MEMORANDUM

To: Auckland Council: Michael Luong
From: Barker & Associates
Date: 3 April 2020
Re: Waihoehoe Plan Change Request: Planning RFI Response

Waihoehoe Plan Change Request – Oyster Capital

Figure 1: Drury Train Station Project Timeline Source: NZTA

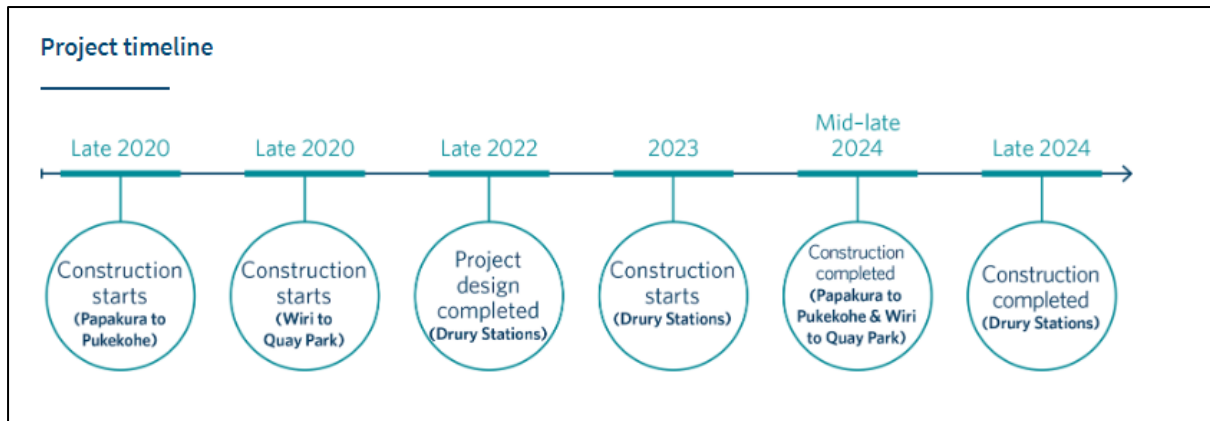
Request 2: *Given the importance attached to transit access in managing transport pressures, as well as shaping urban form, has consideration been given to the plan change only coming into effect once the Drury Central train station is operational? Could provision be made for enabling works to occur in the meantime?*

Delaying the Plan Change so that it comes into effect once the Drury Central train station is operational is not necessary nor is this supported. Since the lodgement of the Drury East Plan Change applications the Government has committed to funding the Drury Central Train Station, with construction due to be completed late 2024 **refer Figure 1**. Given it is likely to take two years for the Plan Changes to become operative followed by two years of enabling works to prepare the land at Drury East for development, it is highly likely that the train station will be operational prior to the occupation of any new dwellings, retail or commercial buildings. As there is general alignment between the delivery of the train station and construction of Drury East getting underway, it is not necessary to delay the Plan Change.

Notwithstanding that there is alignment of the timeframes, the proposed delay of the Plan Change is not supported. It is not essential for the Drury Central train station to be aligned with the first dwellings to deliver a development that is well supported by public transport. Now that there is commitment from the Government to deliver the Drury Central train station by 2024 the Plan Change can with more certainty seek to enable a planning framework that seeks to respond to this through ensuring there are road, walking and cycling connections to the train station at the early stages of development within the walkable catchment of the station. Auckland Transport's approach to providing public transport services is that they continue to monitor growth and transport conditions and prioritise the necessary infrastructure and service improvements as circumstances demand and budgets and practicalities allow¹. Therefore, demand will drive the investment in supporting public transport services and a level of development is necessary prior to completion of the train station will provide a population to support investment in supporting bus networks.
